IMPACT OF MASSING ON FRONTAGE

HTVIA - VIEW 1 - MILLENNIUM GREEN

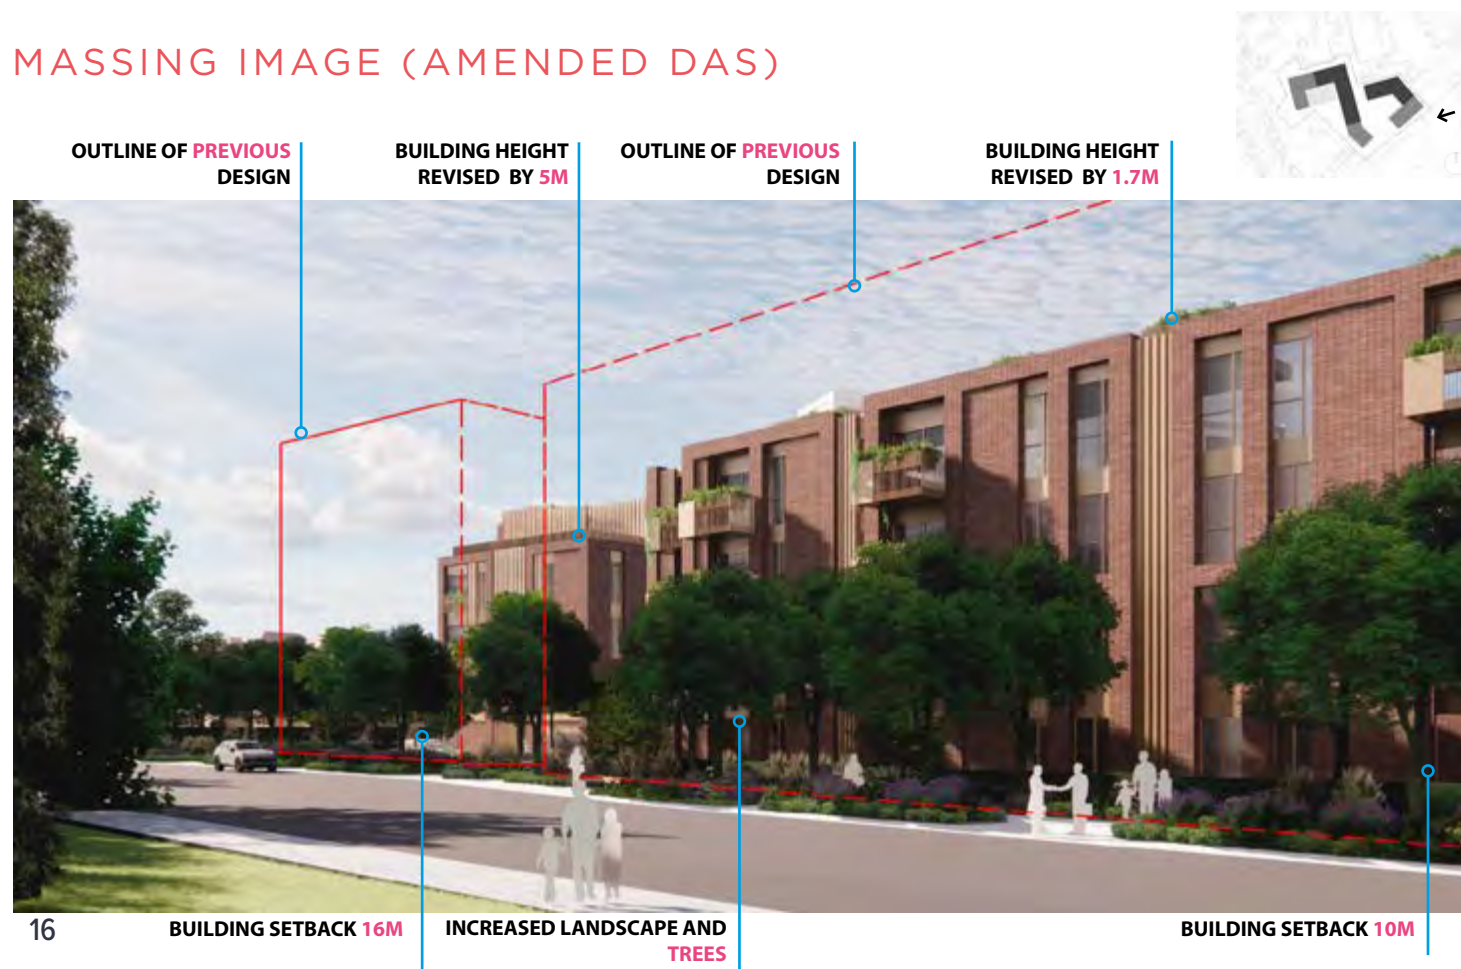
- By both aligning the frontage buildings to the existing building line and reducing the massing in line with existing buildings the impact of the scheme on the frontage is considered to be acceptable and positive.

- View 1 is representative of the view from the rear of the Millennium Green. Whilst there is significant visibility to the rear of the frontage in the refused scheme, this offers an element of depth and interest, which is considered largely acceptable from this view.

- The amended scheme is also considered appropriate from this view aided by the setback and proposed double tree line and is of a more residential context. Buildings at the rear add interest and not seeing the entire rear form is more contextually appropriate than the refused scheme.

- From the street edge the rear mass will not be perceived.
- The narrowing and stepping of Block A reduces the frontage impact and helps the site to assimilate well into its residential context.

SECTION 7-7 - THROUGH NO.46 WOODCOTE GREEN ROAD

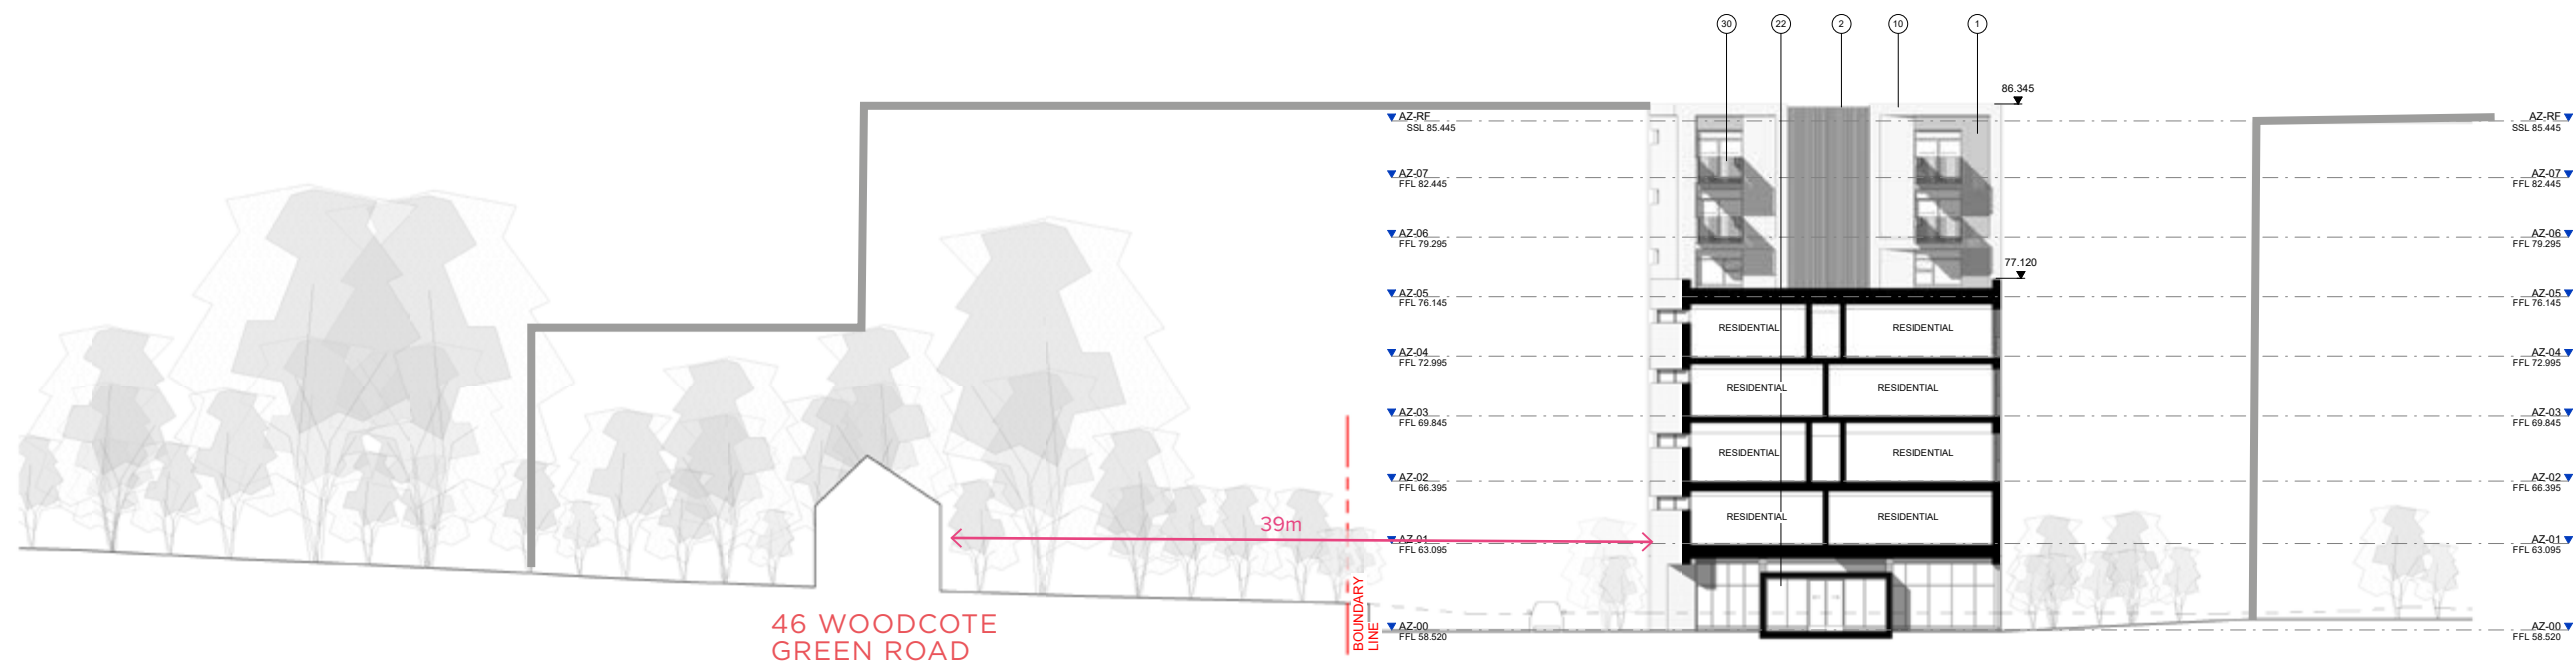
- Overall massing has been reduced which assists the relationship with the context.
- Lower block responds sensitively to adjacent residential dwellings.
